AGENDA
MAY 7, 2019
CITY OF LAVON
PLANNING AND ZONING COMMISSION
SPECIAL MEETING
CITY HALL, 120 SCHOOL ROAD - LAVON, TEXAS
6:30 PM

**CITY OF LAVON
CITY COUNCIL
Agenda Brief**

RE: Final Plat and Final Engineering Plans
Traditions at Grand Heritage Phase 2
111 SF Lots, 2 Open Space Lots and City Dedication on 30.485 Acres.

Re: Traditions at Grand Heritage Phase 2, 111 Lots, 3 open space, 30.485 Acres
Final Plat

GRADING PLAN	
TRADITIONS AT GRAND HERITAGE PHASE 2	
CITY OF LAVON	
COLLIN COUNTY, TEXAS	
100% COMPLETE FOR PERMITS DATE: 04/16/2019	20180005.00

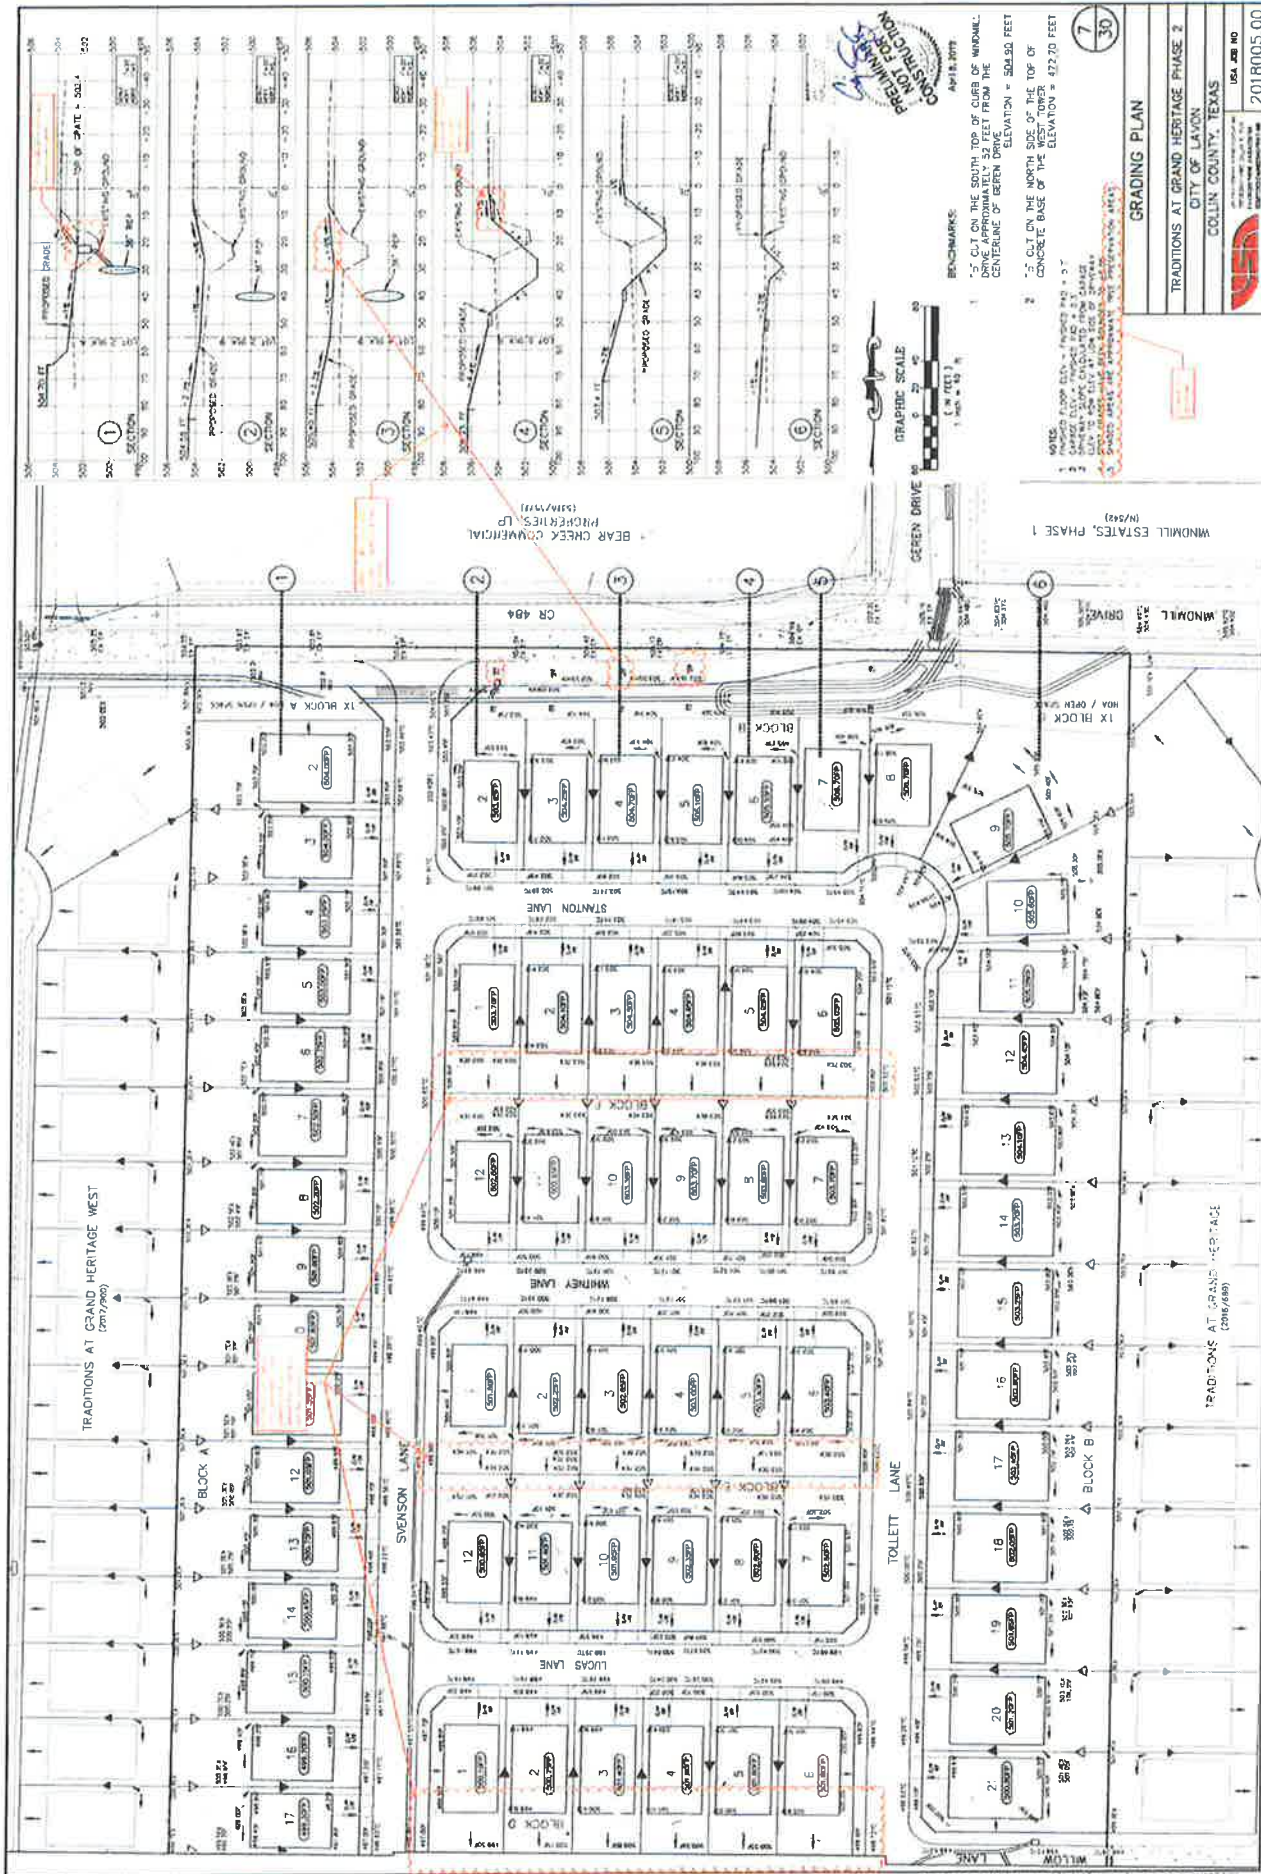
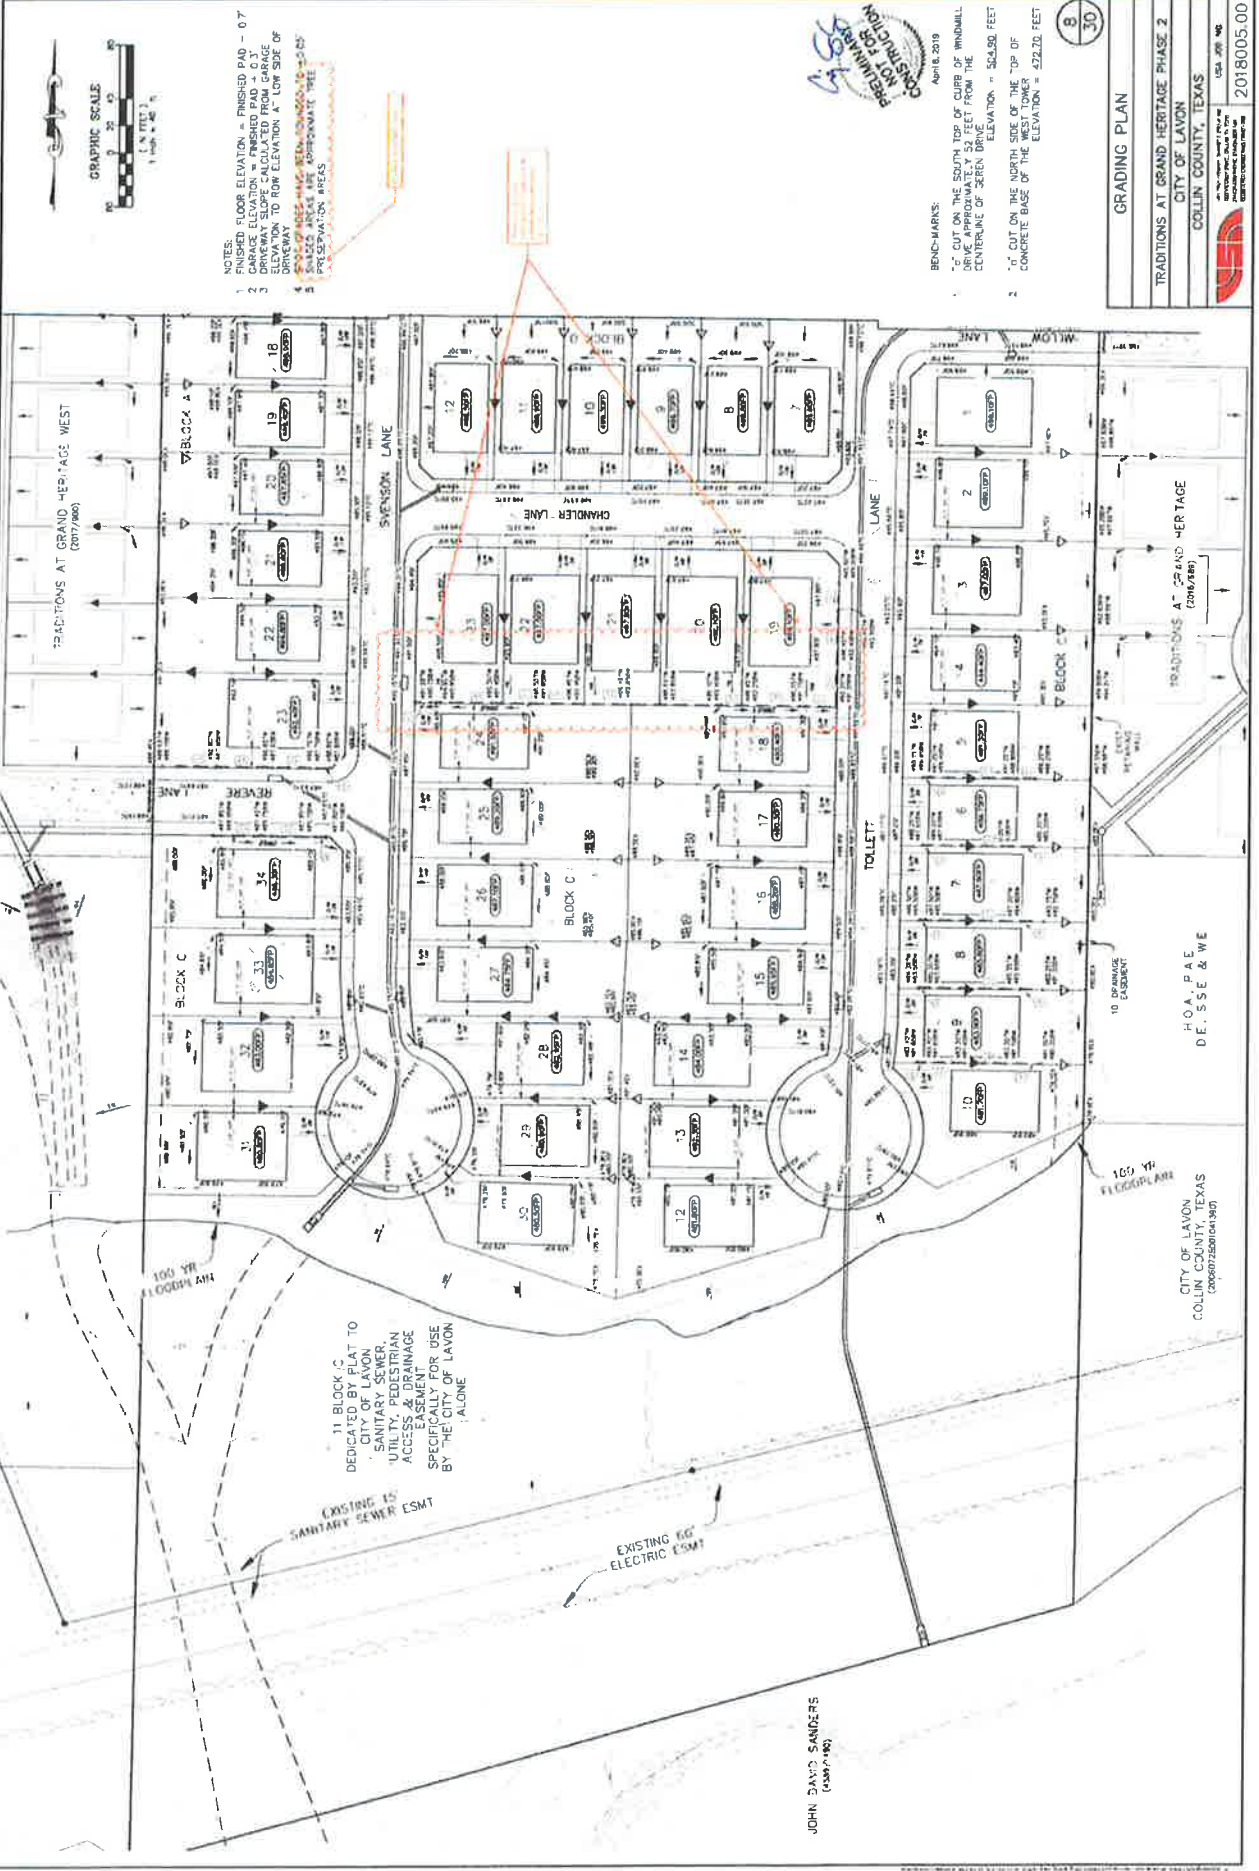
Grading Plan (Sheet 7 of 31)

11. **We recommend that sections be provided along CR 484 to clarify the proposed ditch and storm drainage.**
As requested, we have added sections along CR484 as requested on the Lot Grading Plan.
12. **Slopes from the edge of road to the ditch appear to be too steep. We recommend a maximum of 10% in this area.**
The steepest proposed slope on one section is approximately 11.1% to achieve a 1% slope from the lot line. The remainder slopes are 5% or less.

Grading Plan (Sheet 8 of 31)

13. **There are several locations with "lot to lot" drainage. Per Ordinance 2008-04-02 this is not allowed.**
We have reviewed Ordinance No. 2008-04-02 and believe that "lot to lot" drainage can be approved, where it is warranted, and is incorporated within new subdivision plans that have criteria set up for approval. Lot to lot drainage has been approved, due to existing slopes running north to south, on both of the adjoining communities. Bloomfield Homes is very attentive to making sure lot grading is performed correctly. Saving of trees on this project is a major factor in allowing this type of lot surface flow.. With this in mind, we have incorporated the following into our Final Plat and Plans:

Grading Plan (Sheet 7 & 8 of 30)

2. Cross sections along CR484 have been provided as requested.
 - a. Section 1 shows a grate inlet that is not shown on the storm sewer plan.
 - b. Section 4 shows a sidewalk. The sidewalk should be shown on the plans.
3. Some of the slopes in the plan view do not appear to match the section views. If these are existing slopes in plan view, then it should be labeled as such for clarity.
4. Slopes shown in plan view do not appear to correspond with sections. If these are existing slopes, they should be identified for clarity.
5. The shaded "tree preservation areas" do not appear to be visible on this sheet (ref Note 5).
6. The grading plans should be updated to reflect the drainage to the side property line (Block D, E, F) and the proposed private drain line (Block C) on the lot-to-lot drainage areas per discussion with the Developer and Engineer.

- Aligned the lot lines to allow for ease of lot flow
 - Provided drainage easements along all lot lines on the Final Plat
 - Stated on the Final Plat that the HOA and the City have the right, but not the obligation, to enforce that the drainage is maintained to the intent of the approved lot grading plans within these drainage easements

- Stated, on the Final Plat, that fences or any other type of obstructions shall not, in any case, impede the lot surface flow as shown on the lot grading plans.

14. **The drainage easement along the east property line of Block C should be HOA maintained.**
We have added a note that this 10' drainage easement will be the responsibility of the lot owner as well as the HOA.

DRAINAGE AREA MAP
 TRADITIONS AT GRAND HERITAGE PHASE 2
 CITY OF LAVON
 COLLIN COUNTY, TEXAS
 2018005.00

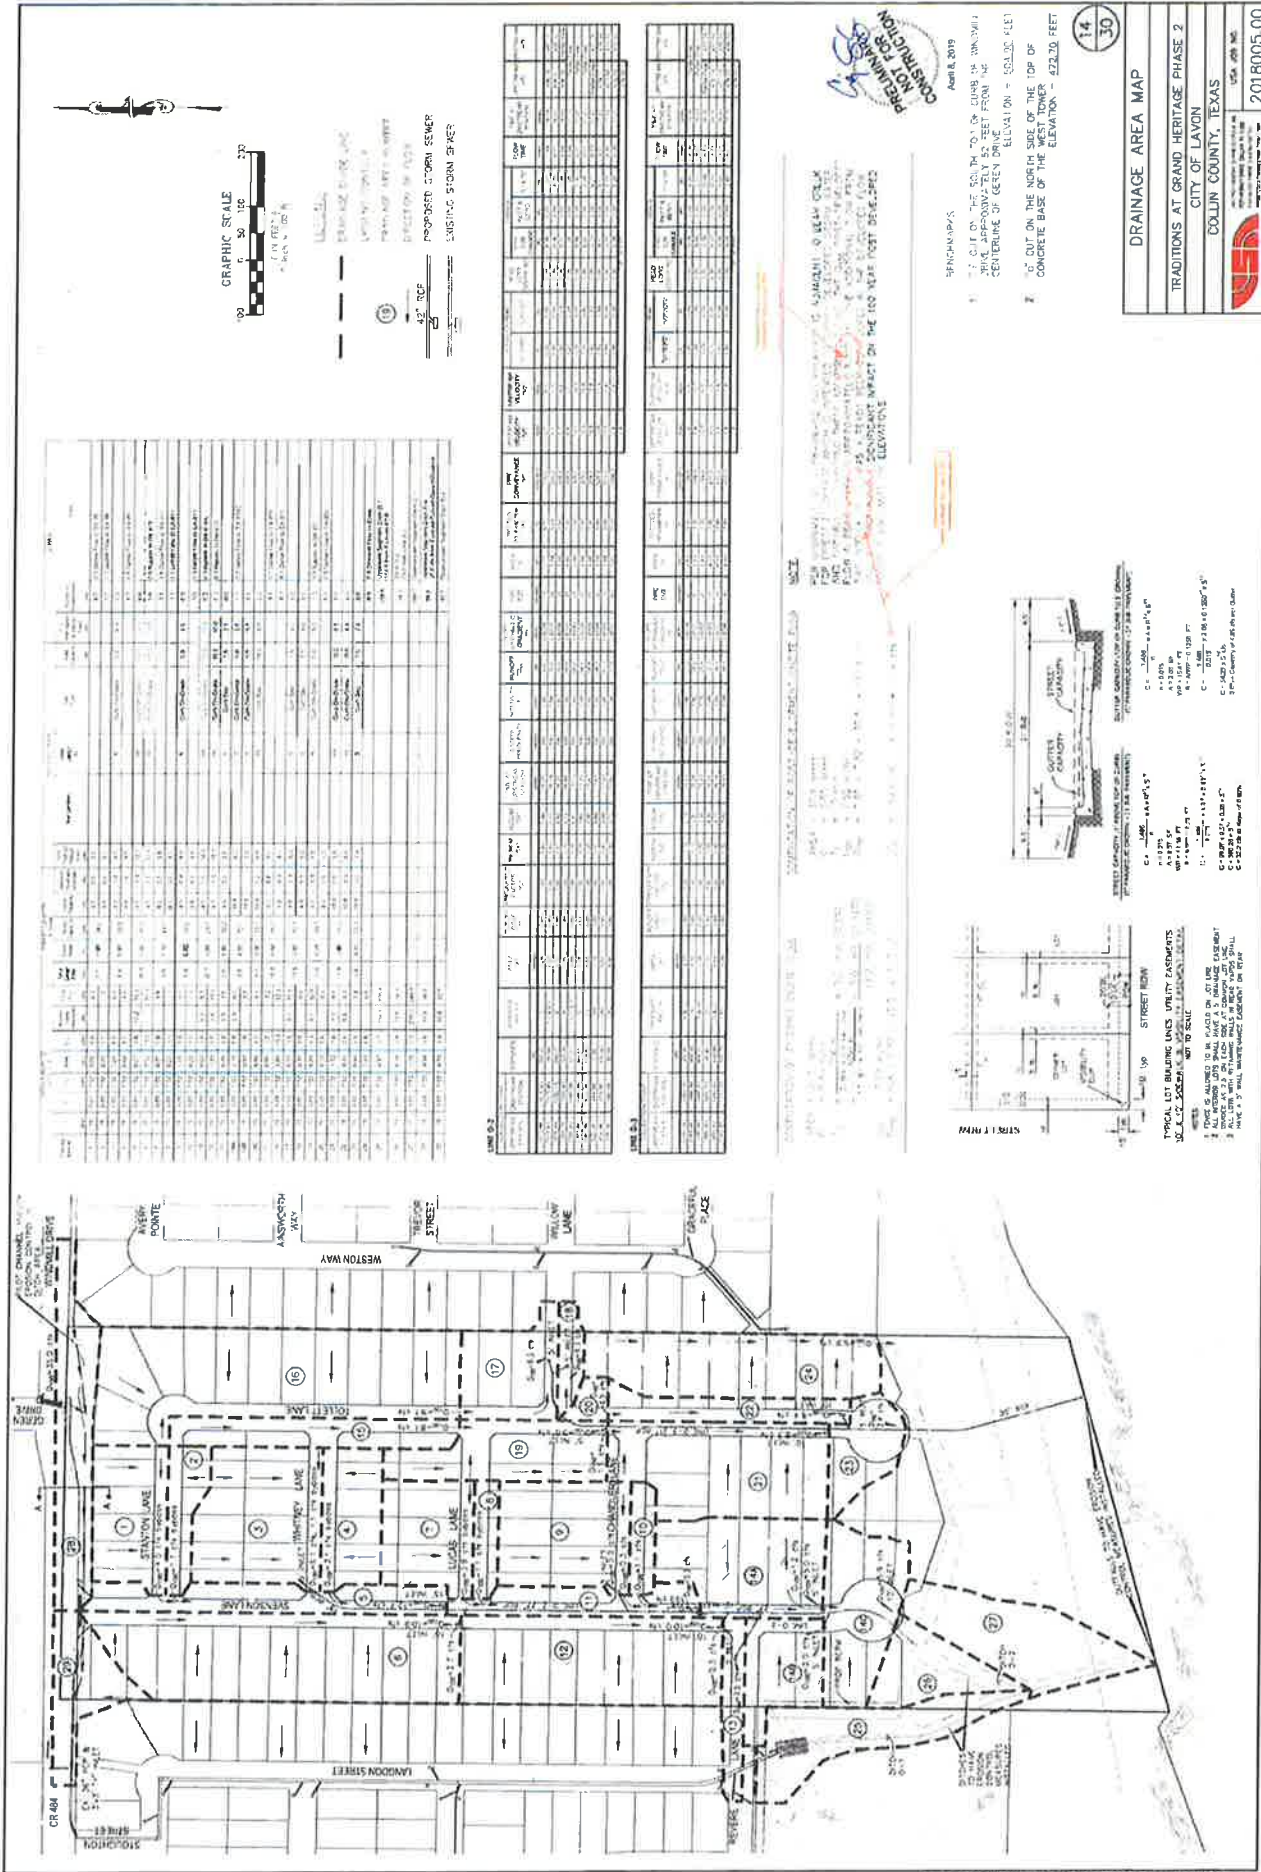
Drainage Area Map (Sheet 14 of 30)

15. This sheet was revised on February 21, 2019.
16. Existing and proposed flow data should be provided. The impact of any increase in flow to Bear Creek, i.e. no detention, must show no significant impact to the flood elevation or floodplain extents.
We have shown both the existing and post developed flows per request. This property is directly adjacent to Bear Creek for direct discharge which is intended to carry the developed storm water and further is capable of carrying this additional flow. The additional post developed flow from this site is approximately 0.5% of the total developed flow in Bear Creek. This will not have a significant impact on the 100 year post developed base flood elevations or the limits of the flood plain.

17. There is a Section A-A shown along CR 484. It is not known where this section is shown on the plans.
This section "A-A" has been removed as it is not needed.

18. There are 2-5' and 1-10' inlet at the end of Svenson Lane. These have been combined in the inlet calculations. Each of these should be shown separately in order to determine the flow to each.
We have divided the drainage areas into three sub-areas/flows and show how they affect each inlet as requested. We have also revised the profile to show the flow correctly.

Drainage Area Map (Sheet 14 of 30)

7. The Engineer should reference the source of the post-developed 9,700 cfs. If the flow cannot be referenced, and the study or data used be made available to the City, we recommend utilizing the preliminary flood study prepared by Jacobs, dated March 1, 2018, for the President's Blvd. Bridge over Bear Creek. This shows a pre-development flow of 7,176 cfs and a post development flow of 8,080 cfs in this reach of Bear Creek.

8. There appears to be a typographic error in regards to the additional flow identified in the note.
9. Curb inlets have been provided at the north end of both cul-de-sacs. The curb inlet at the end of the cul-de-sac on Svenson Lane has a capacity of 15.0 cfs and an expected flow of 5.9 cfs. The cul-de-sac at the end of Tollett Lane has a capacity of 7.5 cfs and an expected flow of 2.4 cfs.
